# TOWN OF ROLESVILLE

## **Addendum #3 Issued November 14, 2018**

Addendum #3 provides answers to the questions raised at the prebid meeting on October 30, 2018 and other questions from bidders as of November 14, 2018.

**GRANITE FALLS BOULEVARD**  
ROLESVILLE, NC

C-1

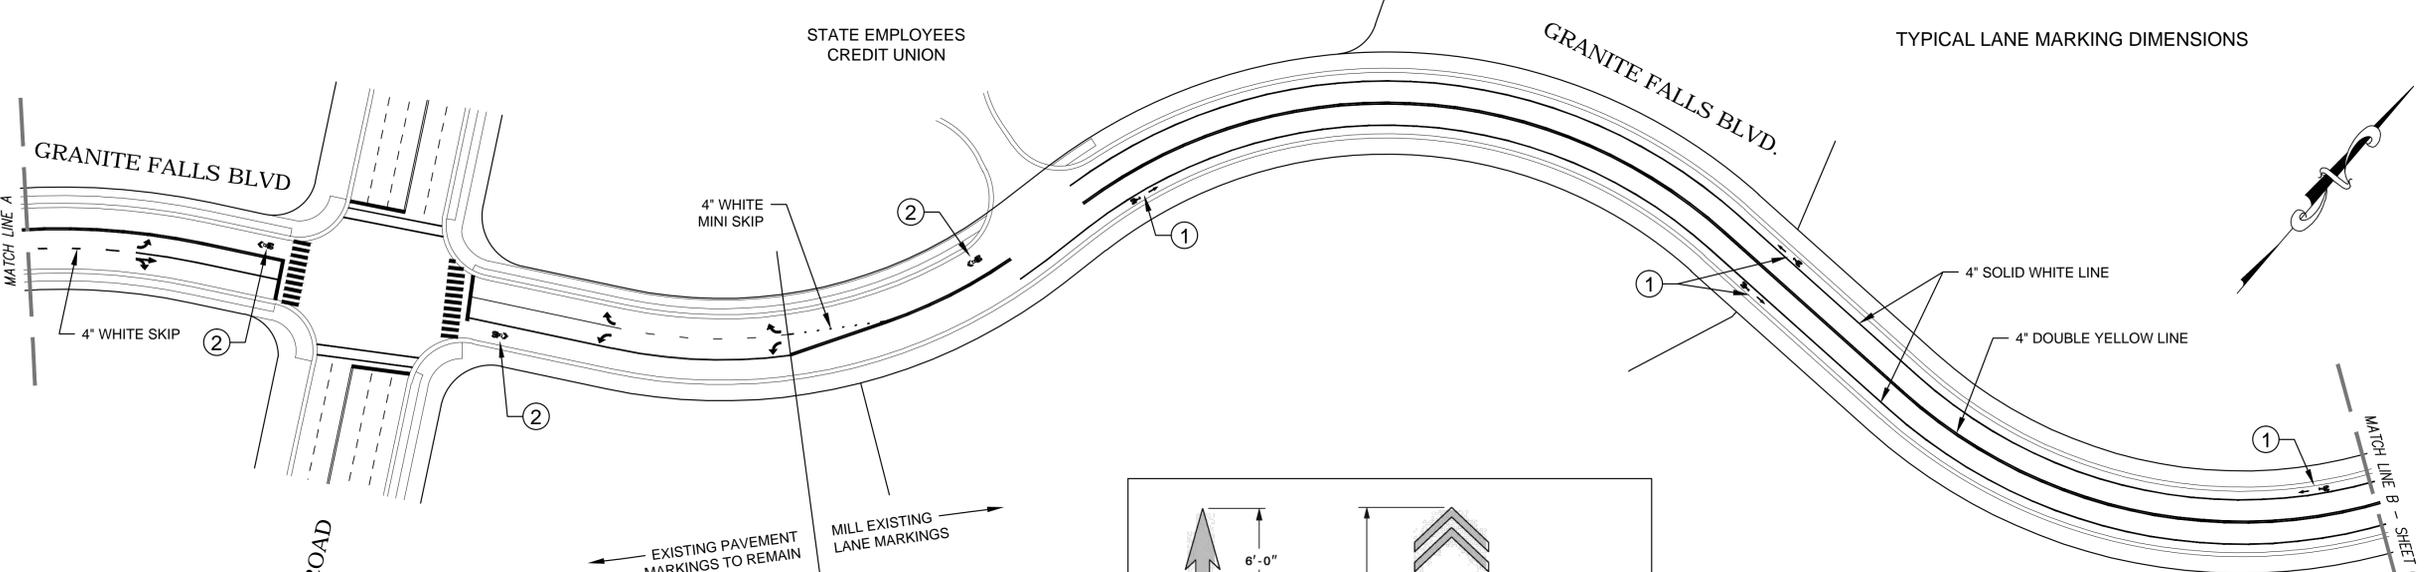
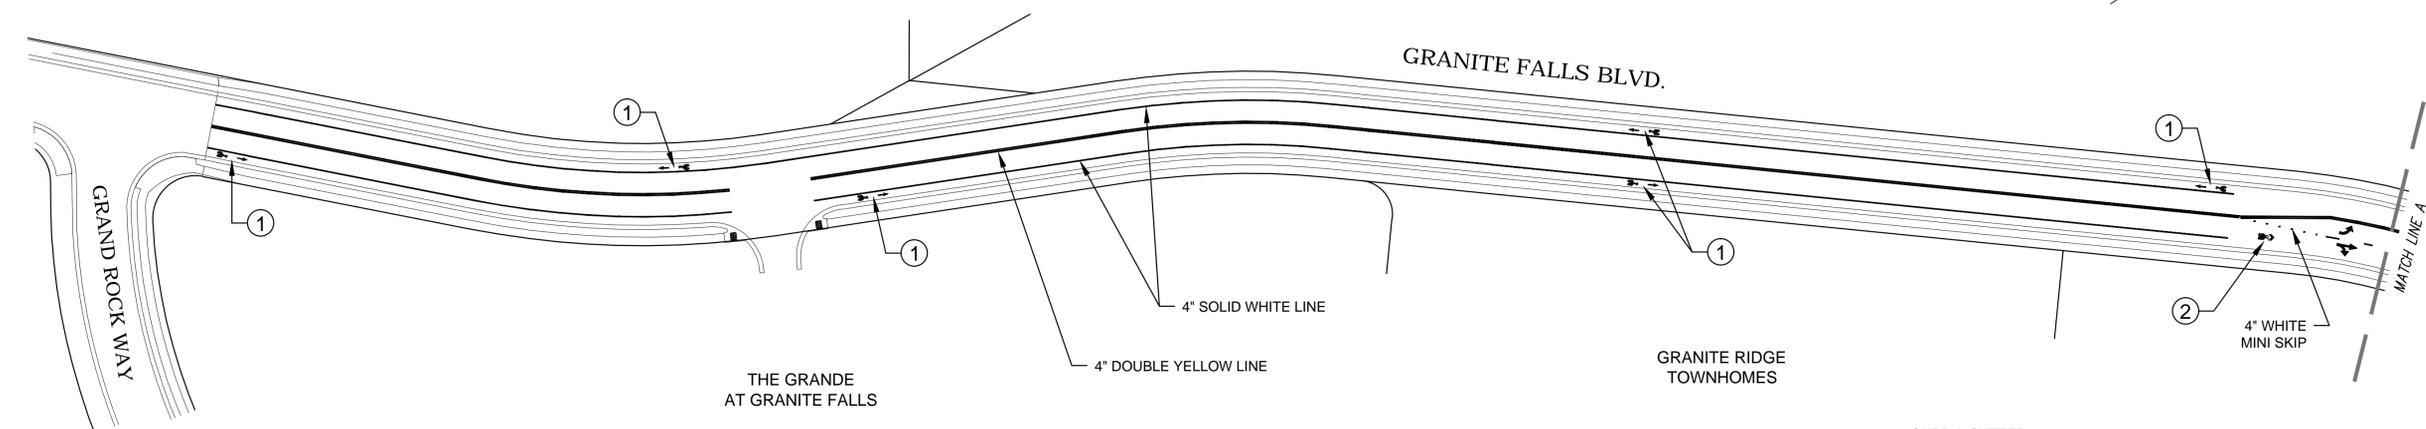
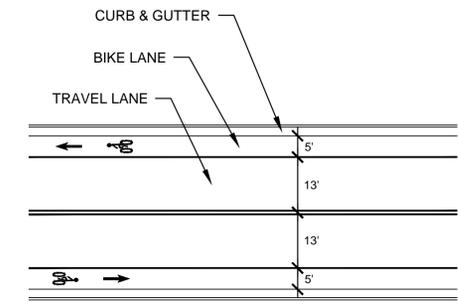
11. Striping plan on existing Granite Falls Blvd; is this to be a separate bid or will these be bid as one project?

A striping or pavement marking plan for Granite Falls Blvd is included in the plan set and please note the bike lane marking goes to Young Street. Additional pay items have been added to the Schedule of Prices. A lump sum pay item is shown for the removal of the existing pavement markings on Rogers Road. Bike lane plans are attached to this addendum.
